**RE: S75W MODIFICATION APPLICATION - THE DAN LAND - MP 06\_0031 (MOD 4) - ENVIRONMENTAL ASSESSMENT REPORT**

In summary, the proposed modification relates to changes to the approved subdivision layout of Stage 10, the final stage of the Dan Land subdivision.

Figure 3: Proposed modification - subdivision layout (with annotations) (Base source: Attachment 1, ADW Johnson)

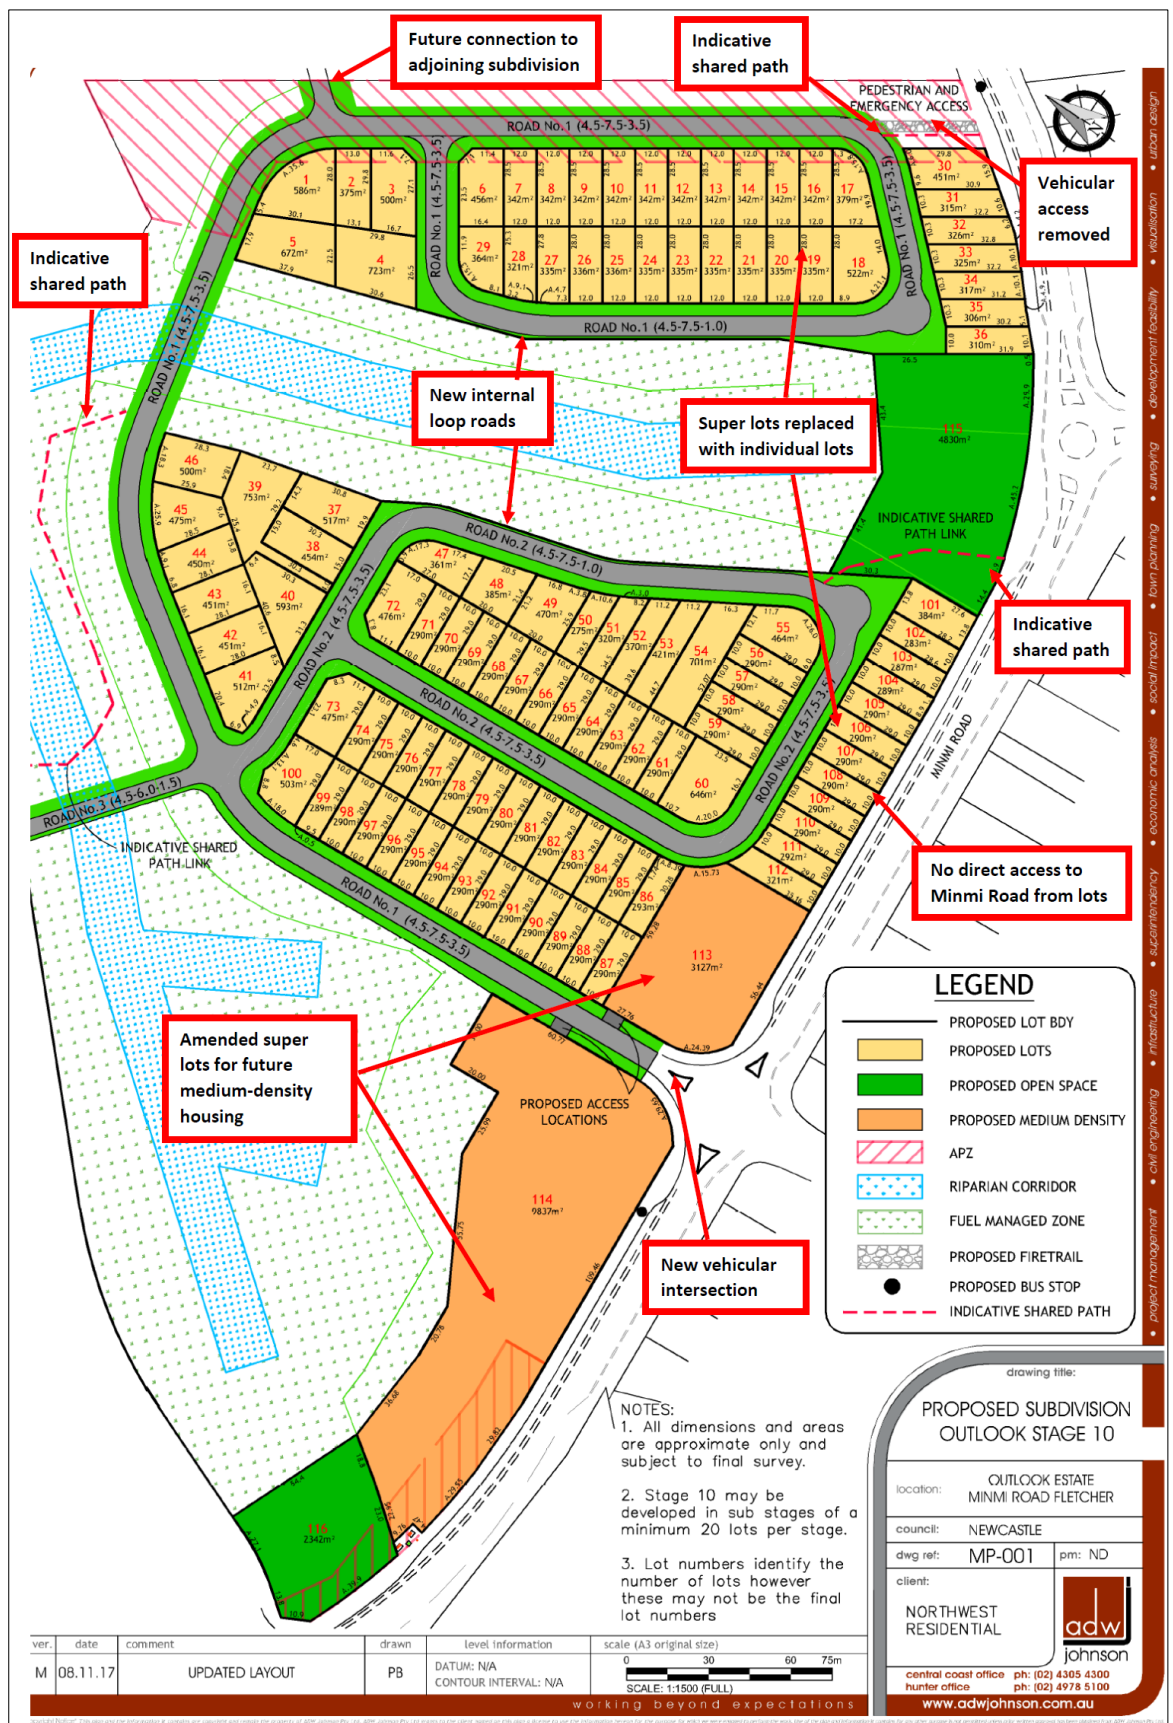
This application seeks to modify the approved subdivision layout for Stage 10 of the Dan Land Concept Plan and Project Approval as follows:

- Replace 8 super lots and reconfigure remaining lots to result in:
  - 112 residential lots, ranging in size from 283m<sup>2</sup> to 753m<sup>2</sup> (most considered 'small lot housing' lots),

- 2 super lots for future medium-density housing (with areas of 3,127m<sup>2</sup> and 9,837m<sup>2</sup>);
  - 2 open space lots (with areas of 4,830m<sup>2</sup> and 2,342m<sup>2</sup>); and

- 1 (residual) community lot
- Increase the total number of lots from 400 to 413 (including 2 super lots) across the entire Dan Land site;
- Provide an amended road layout including the deletion of cul-de-sacs and the creation of 2 internal loop roads;

- Add indicative shared pedestrian and cycle pathways;
- Amend road access arrangements as follows, in order to comply with Condition B10 of the Project Approval (see **Section 3** below):

- Provide a new vehicular road connection to the north-eastern boundary of the subdivision, to allow for a future connection to the adjoining residential estate ('Sanctuary', currently under construction);

- Replace the eastern-most vehicular access point to the estate off Minmi Road with a pedestrian pathway; and
  - Provide a new vehicular access point further west along Minmi Road opposite Highland Way.

Figure 4: Proposed modifications superimposed over approved subdivision boundaries (red dotted lines)  
(Source: Attachment 2, ADW Johnson)

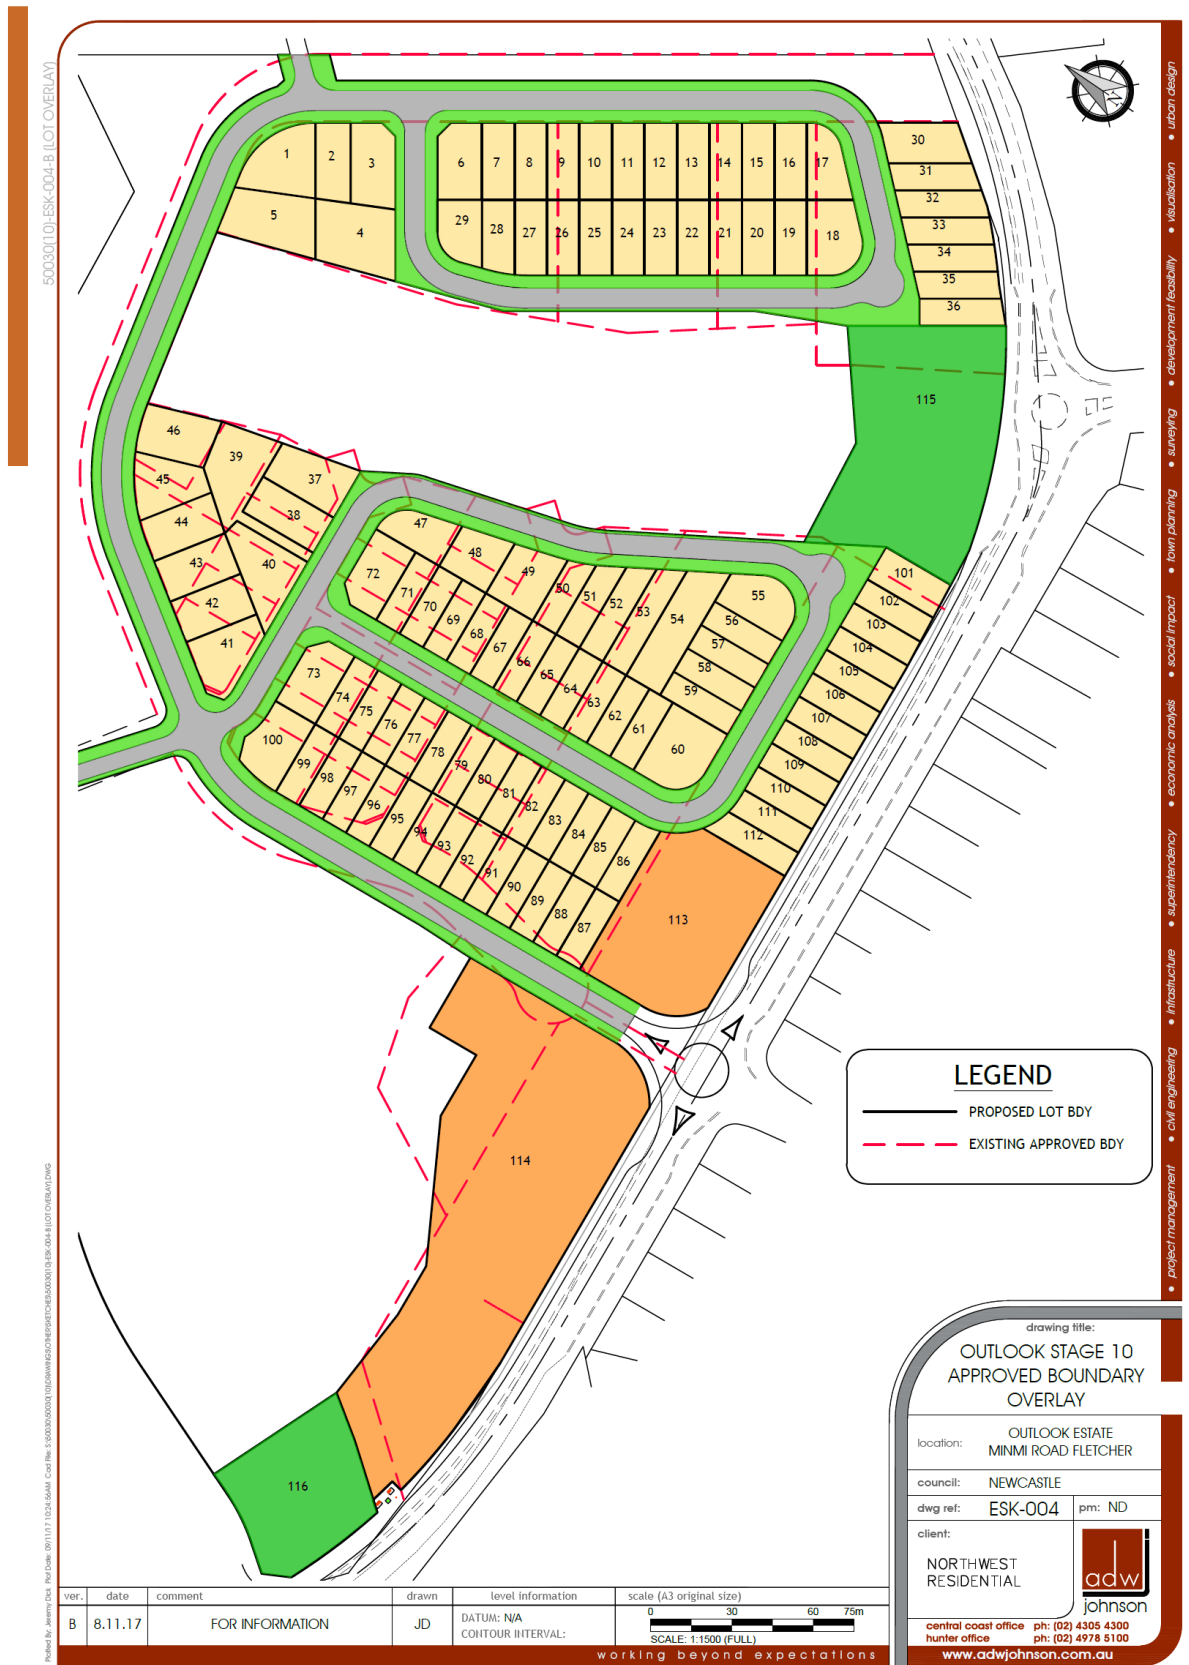
A plan showing the proposed modifications superimposed over the approved subdivision layout is provided at **Attachment 2**. An extract is shown in Figure 4 below. This plan demonstrates how the proposed subdivision footprint remains generally within the approved subdivision boundaries. However, due to minor boundary adjustments made as a result of the topographical constraints, the overall area of development is less than the area approved.
